ADDENDUM NO. 1

NORTHERN KENTUCKY WATER DISTRICT
TAYLOR MILL WATER TREATMENT PLANT
ELECTRICAL AND BASIN IMPROVEMENTS

ISSUED: FEBRUARY 14, 2014

ADD 1-1

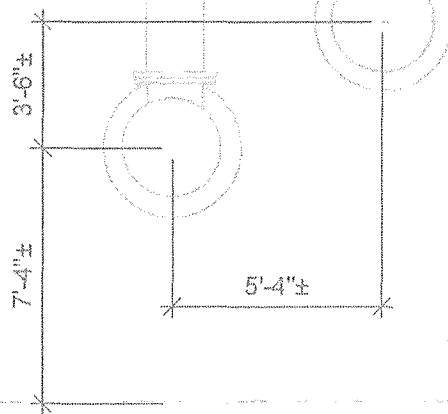
1. SHEET M-01-001
 - A. BASEMENT MODIFICATION PLAN: **REPLACE** "BASEMENT MODIFICATION PLAN" with the attached Figure ADD 1-1.

7. It will be difficult to remove and replace the (2) 20" influent valves in the basement without installing 20" dismantling joints or flanged coupling adapters. Please advise if it is acceptable to add either of these next to the 20" butterfly valves.

1. CONTRACTOR SHALL REMOVE AND REPLACE BUTTERFLY VALVES.
2. CONTRACTOR SHALL PROVIDE AND INSTALL FLANGED COUPLING ADAPTERS AS SHOWN.
3. CONTRACTOR SHALL REINSTALL SAMPLE LINE AS REQUIRED.

Response: Flanged Coupling Adapters will be installed per attached Figure ADD1-1 of this Addendum.

ADD 1-2

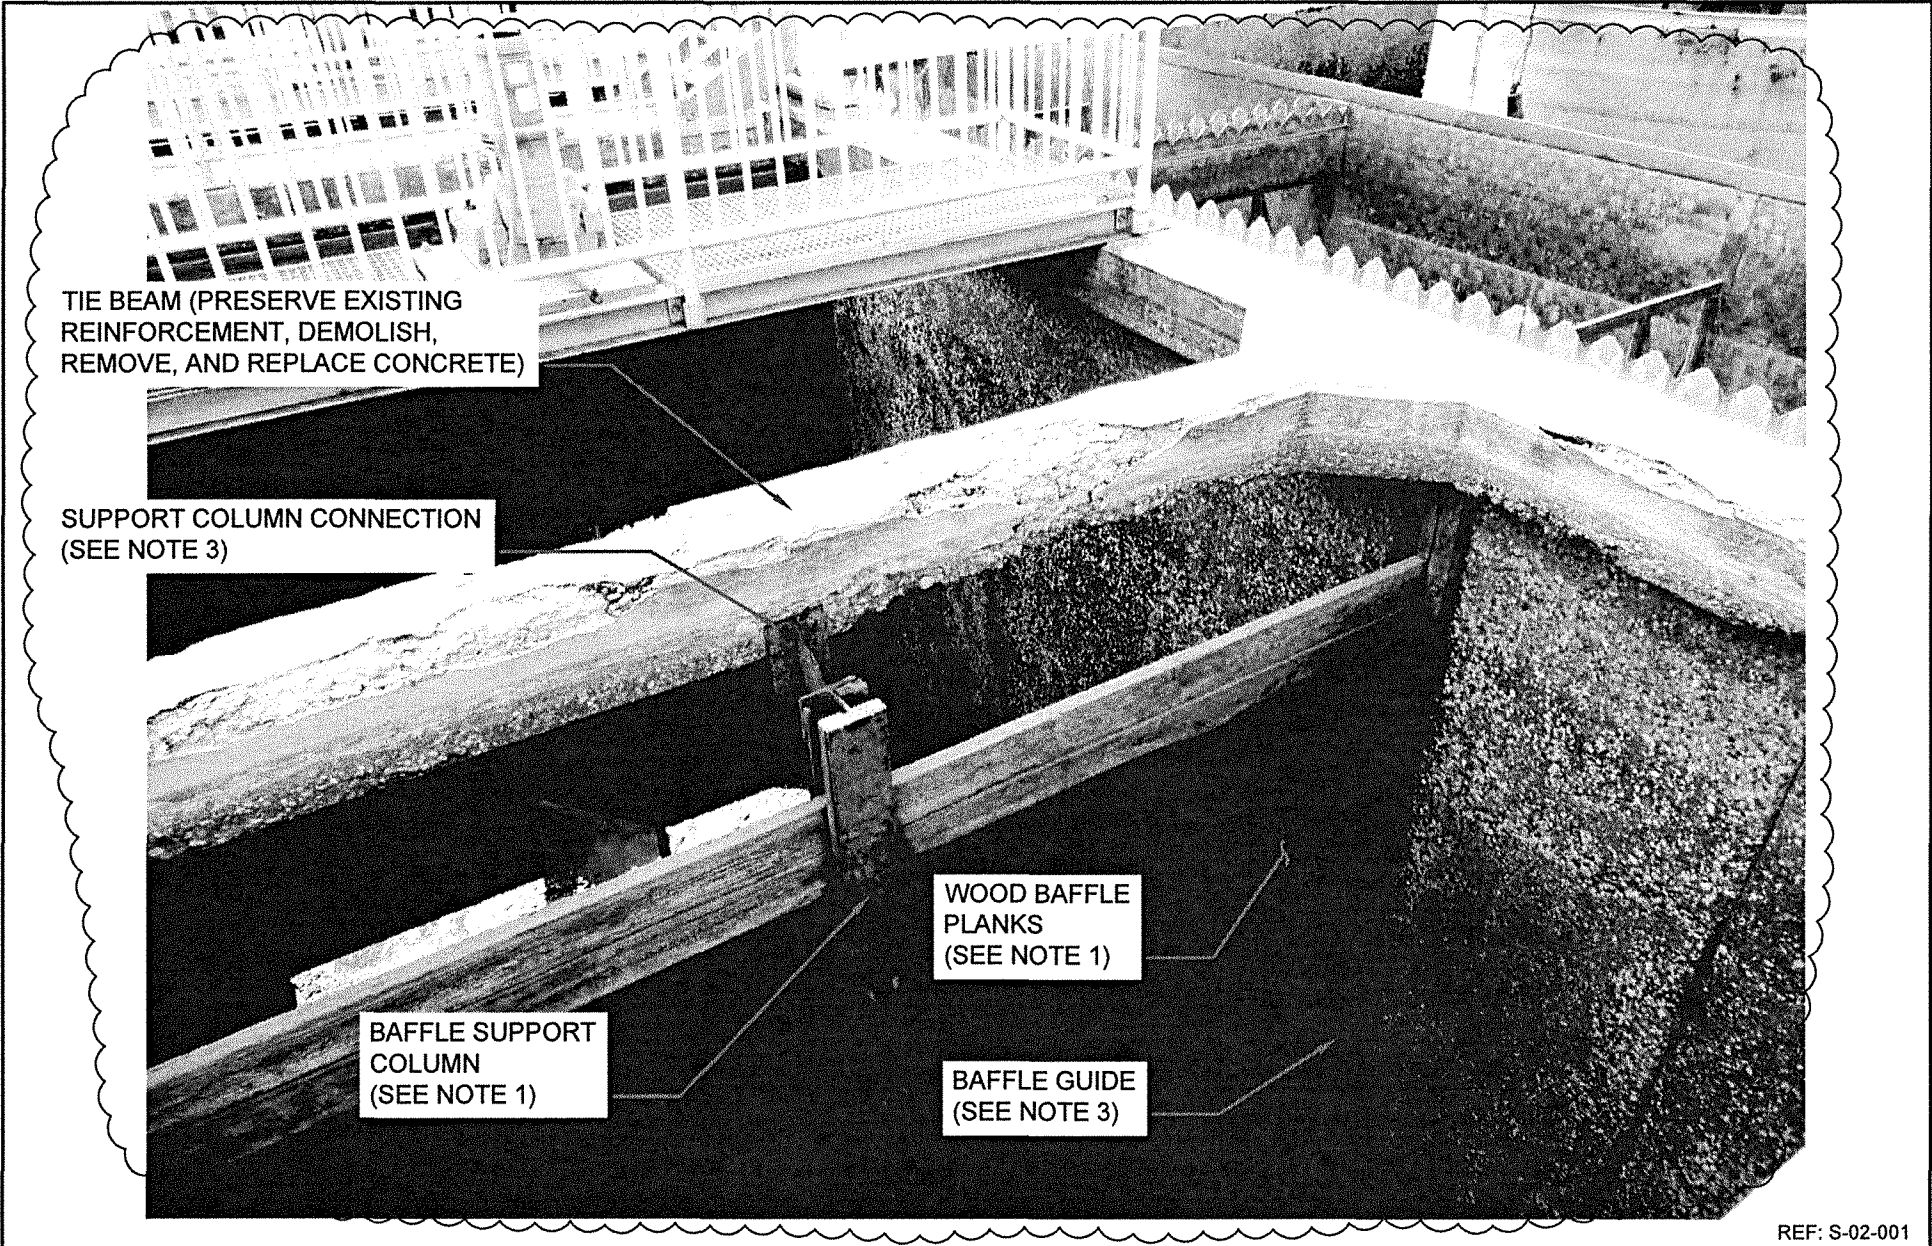
LABEL: **REPLACE** the callout label "REMOVE EXISTING BAFFLE COLUMN ANCHORAGE (SEE NOTE 1) (TYP OF 4)" with "REMOVE EXISTING BAFFLE COLUMN ANCHORAGE (TYP OF 8) (SEE NOTES 1, 3, AND ADDENDUM NO. 1 FIGURE ADD1-2)".

LABEL: **REPLACE** the callout label "REMOVE WOOD PLANK BAFFLES (TYP OF 8) (SEE NOTE 1)" with "REMOVE WOOD PLANK BAFFLES (TYP OF 8) (SEE NOTES 1, 3, AND ADDENDUM NO. 1 FIGURE ADD1-2)".

19. Since there is no demolition detail provided of the construction area where the wood baffles are being removed, I have assumed the section 3/S-02-003 which seems to show a 12"x12" concrete beam spanning across the tank is what we are removing. Please confirm.

20. There are no existing or new details provided to show the configuration of the wood baffles. Can a detail be provided?

TIE BEAM (PRESERVE EXISTING REINFORCEMENT, DEMOLISH, REMOVE, AND REPLACE CONCRETE)

WOOD BAFFLE PLANKS (SEE NOTE 1)

Response: Wood baffle planks span across Flocculation Basin to full height and are supported at the middle of the basins by a steel column. As noted in Addendum Attachment Figure ADD1-2, the steel column is anchored to the concrete tie beam shown in Section 3/S-02-003; this anchorage is noted for removal and re-installation on Sheet S-02-001. As shown in Section 3, reinforcing in the tie beam shall be preserved, concrete shall be removed.

Response: Wood baffle re-installation shall match existing, refer to Addendum Attachment Figure ADD1-2.

ADD 1-3

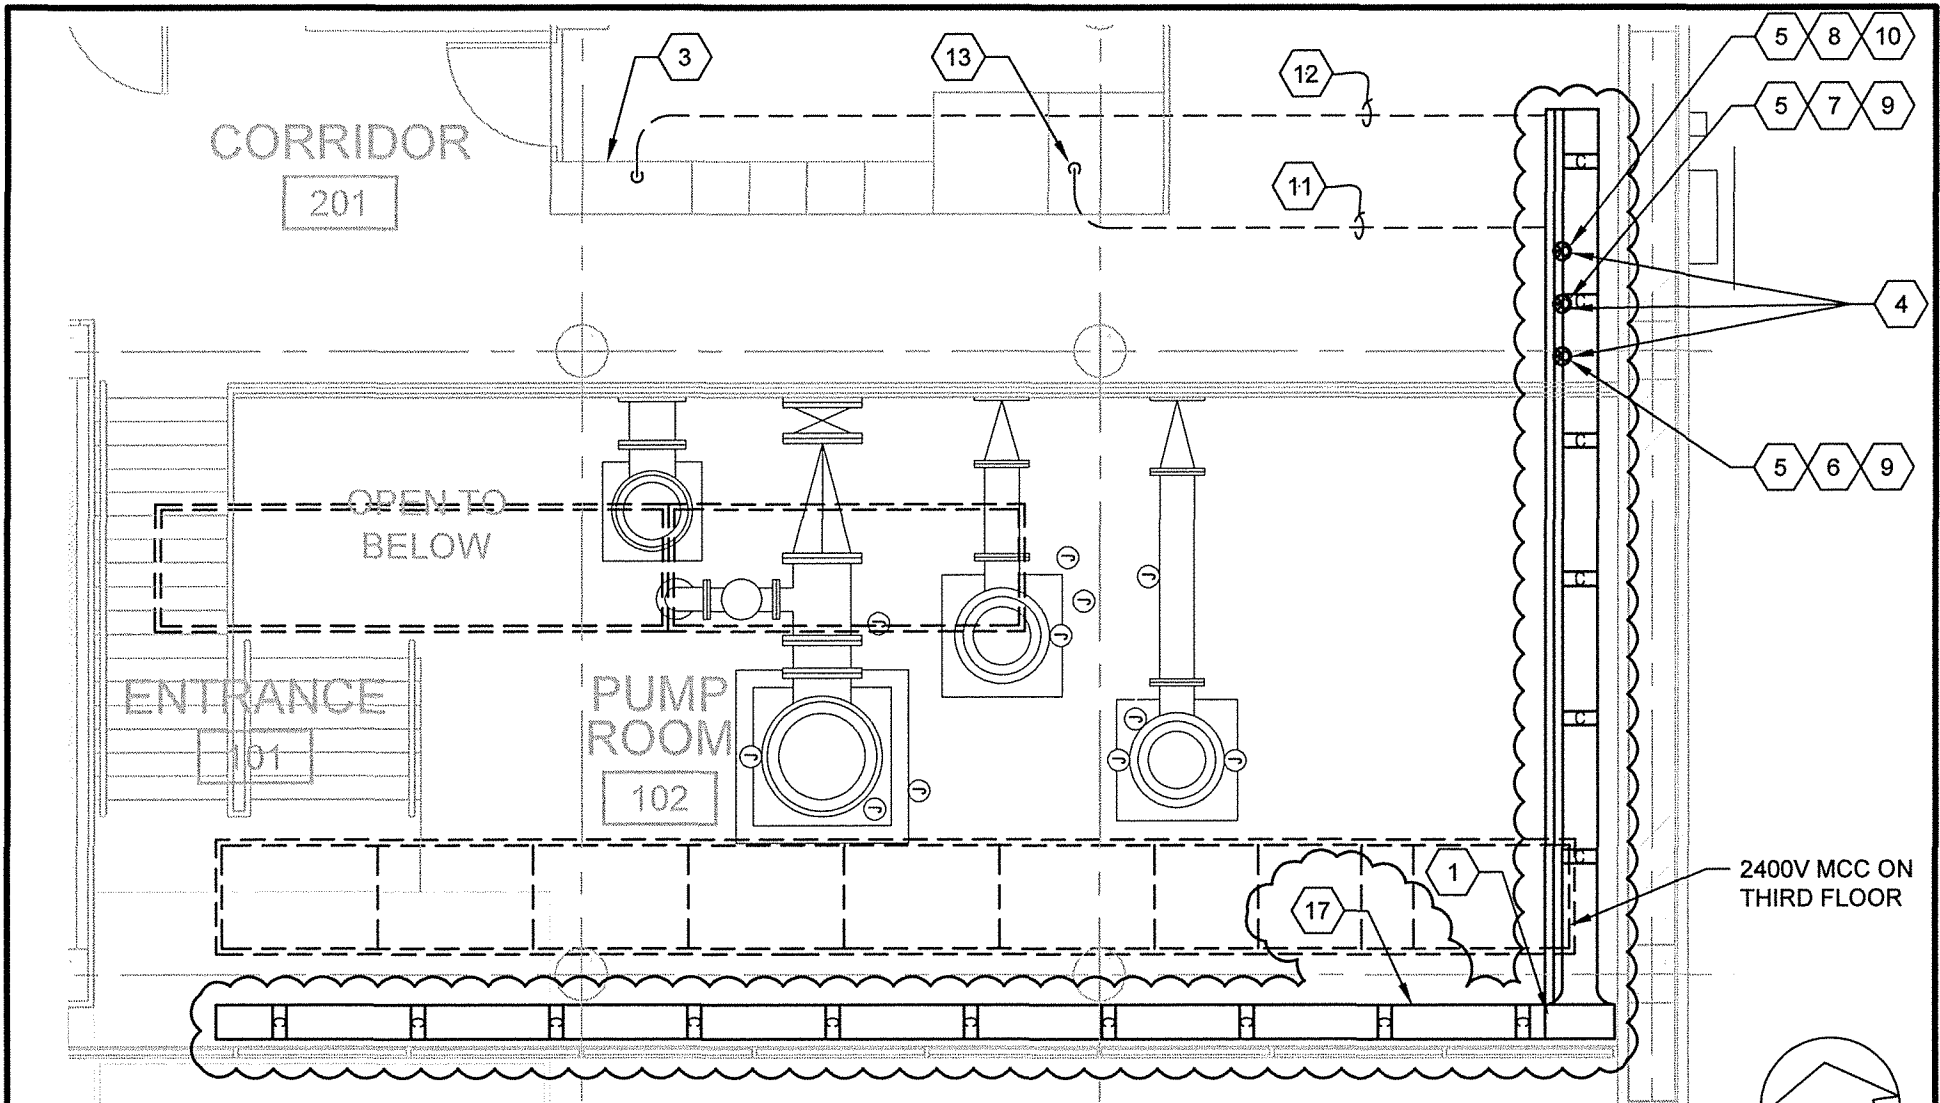
A. **REPLACE** portions of the plan with the attached Figure ADD 1-3.

A. **ADD** the following KEYNOTE 17 (See Figure ADD1-3):
New 6" wide, 5" deep, 6" rung spacing aluminum cable tray with a barrier in the middle for control and signal cables. Hang below the 12" cable tray. Field coordinate final location to coordinate with window mechanisms. Remove and replace ceiling as required to install supports and cabling."

17. Can the proposed cable tray get past the concrete beam in the ceiling of the pump room?

Response: See Figure ADD1-3 of this Addendum.
